LOT # 185  
15,080 SF

APPROVED AS NOTED  
NS

PLOT PLAN PREPARED FOR  
SWEETWATER CUSTOM HOMES  
PLOT PLAN LOT # 185  
SUMMERGLENN @ AUSTIN OAKS  
SECTION 7  
INSTR. # 9805962  
PLAT BOOK # 10, PAGE # 5  
4773 AUSTIN TRACE

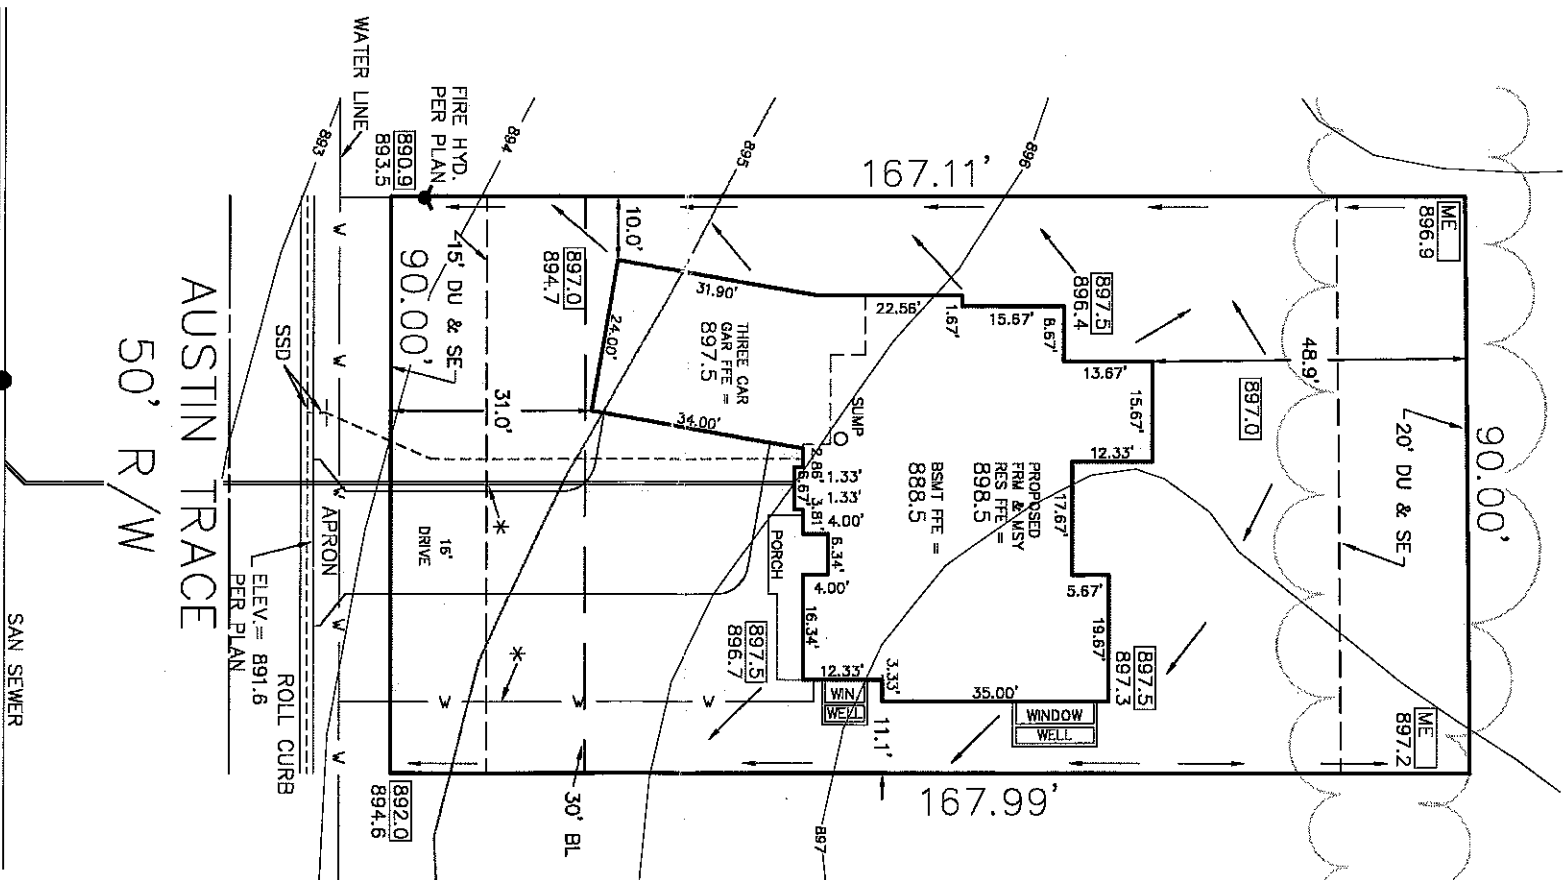
ALL MUD IN STREETS FROM TRUCKS LEAVING LOT TO BE CLEANED AT THE END OF EACH DAY **OR Silt FENCE**

AREA OF WATER TAP TO BE BACKFILLED WITH GRANULAR MATERIAL TO WITHIN 10" OF TOP OF CURB. **SEE GUIDELINE #3**
